## **Traffic Statement**

**PROJECT**: Proposed Residential Development

**LOCATION**: Lot & Section E DP; 6934 184 – 192 Restwell Road, Prairiewood

Figure 2 - Swept path analysis R18 - R23

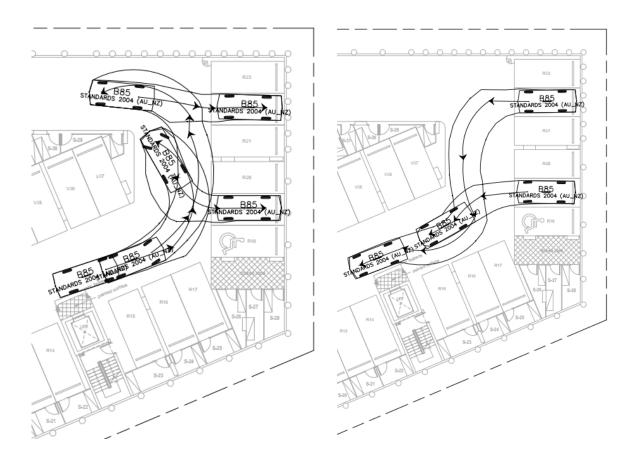
"Swept path analysis was undertaken by Council officers in accordance with Design Vehicle and Turning Path Template – Aust roads. Based on the swept path analysis, concerns are raised in regard to the maneuvering aisle width (5.8m) adjacent to parking spaces (parking space numbers R66 - R71) at Basement Level 2 and the aisle width (5.8m) adjacent to parking spaces (parking space numbers R18-R23)"

The aisle width is 5.8m in front of parking spaces R66 - R71 & R18 - R23 which provide a sufficient space for maneuvering of vehicles to park in these parking spots according to AS2890.1. please refer to attached swept path analysis plan T08 & T09.

Figure 3 – standard Design envelope & R18 dimensions

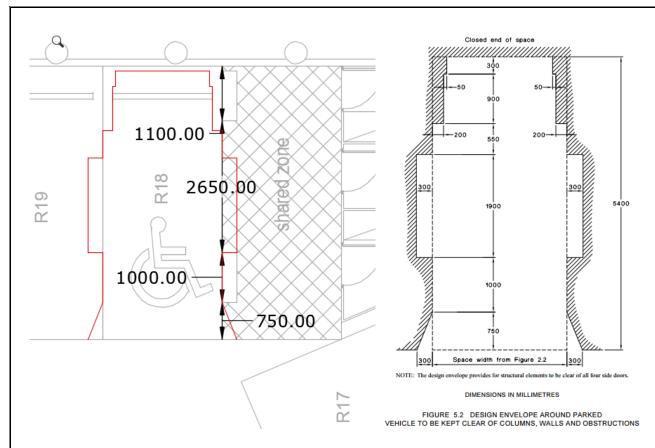
"The columns located adjacent to the disabled parking spaces (R18 & R66) are considered as obstructions that will restrict door opening"

Please refer to the below figure showing the design envelope around the parked vehicle according to AS2890.1 part 5.2 figure 5.2 and the two columns adjacent to parking spaces showing there will be sufficient space for door opening according to AS2890.1
